ZONING BOARD OF APPEALS STAFF REPORT

MEETING DATE: September 8, 2026

REGARDING: 22020 Meadowbrook Road #50-22-36-151-013 (PZ26-0041)

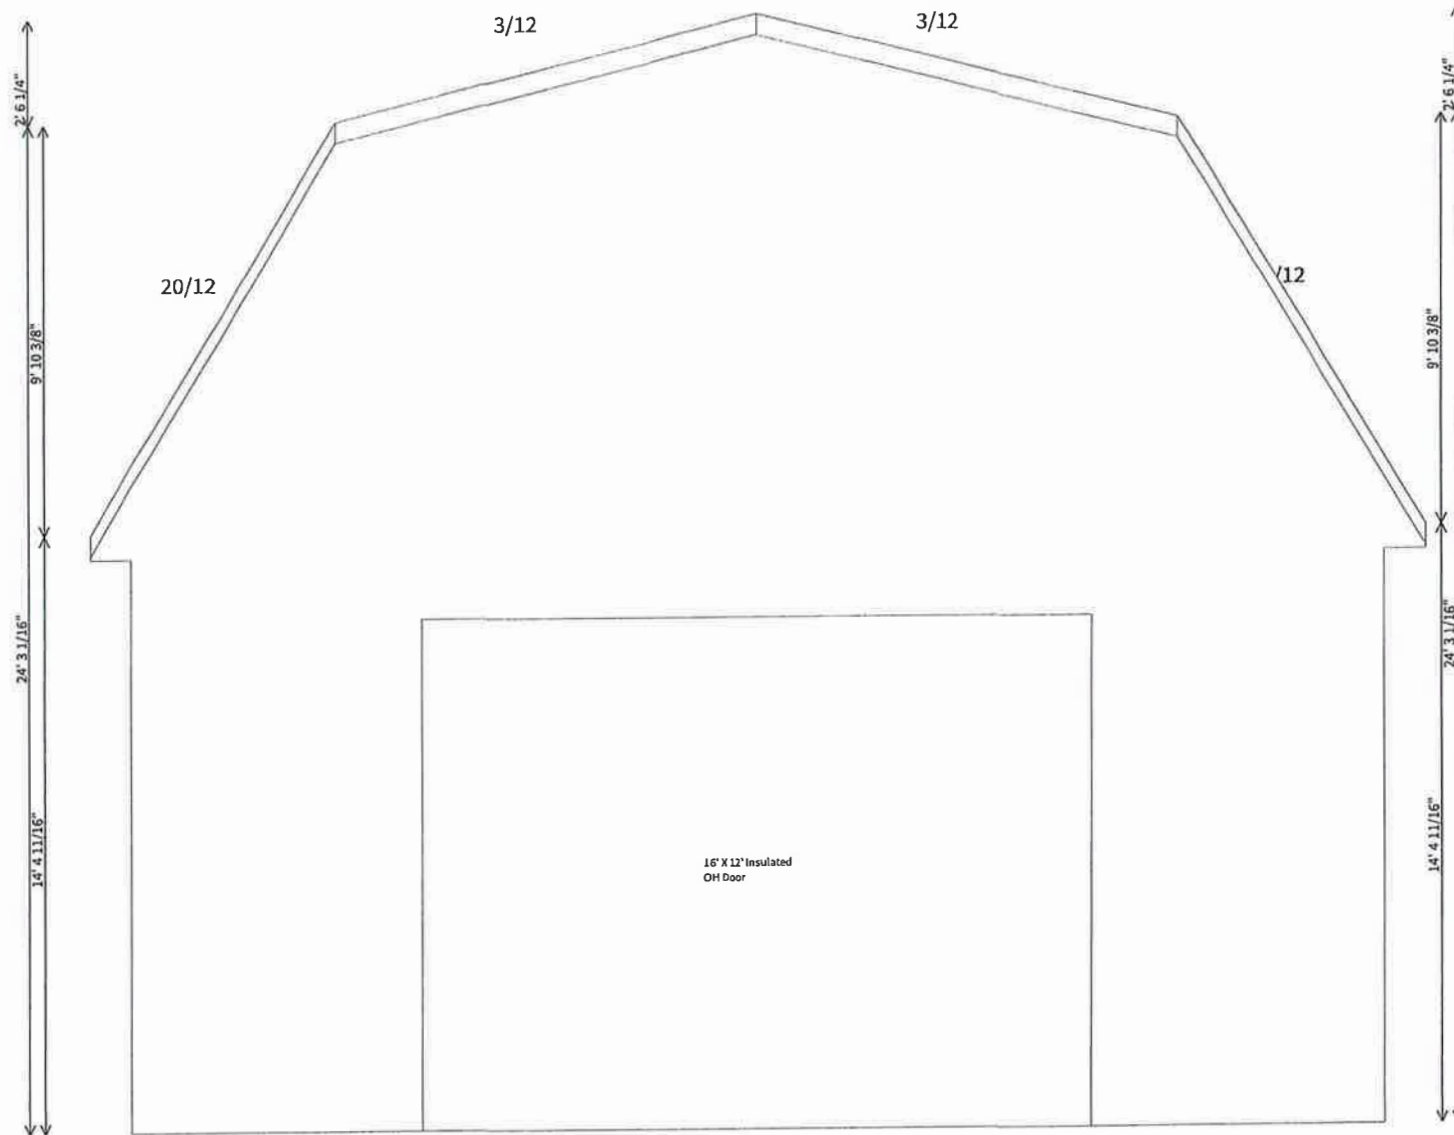
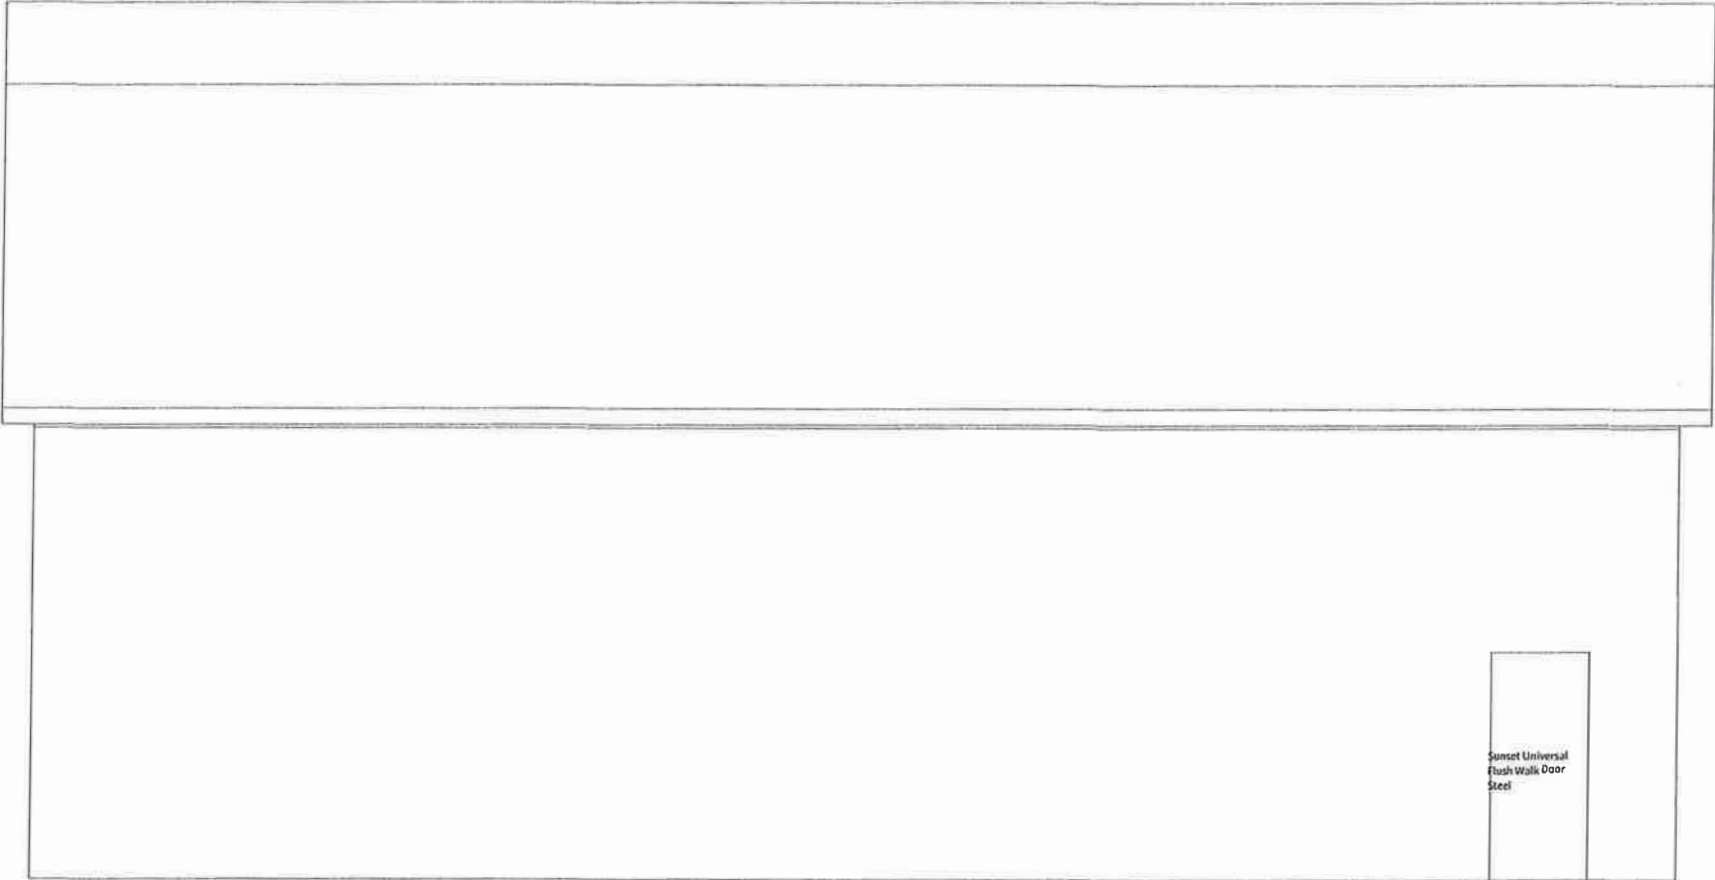
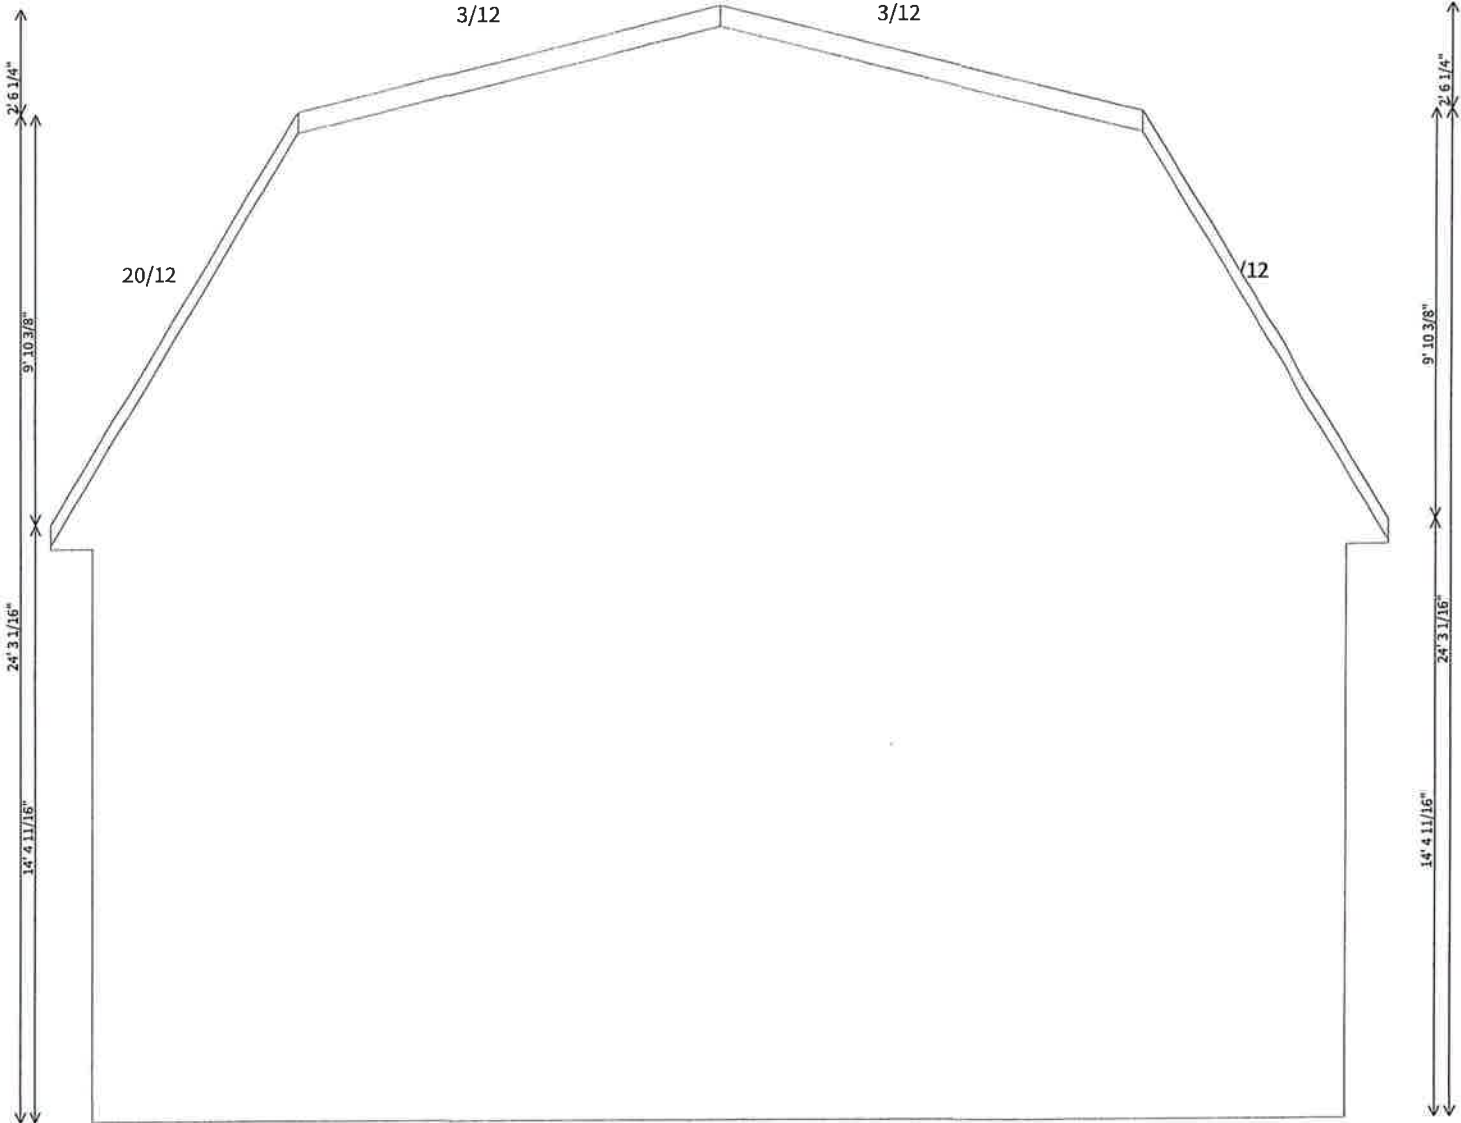
- 1) A 1,860 SF aggregate variance ($870+240+1600 = 2,710$) – 850 SF allowed = 1,860 SF requested (319% allowed size increase)
- 2) A 6' height increase variance (14' allowed), mean height is 20' (Full height is +/- 26'-9")
- 3) A variance to allow the total aggregate accessory area to exceed the principal building area.
Principal building area = 1,816 SF footprint, total accessory = 2,710 SF – not permitted
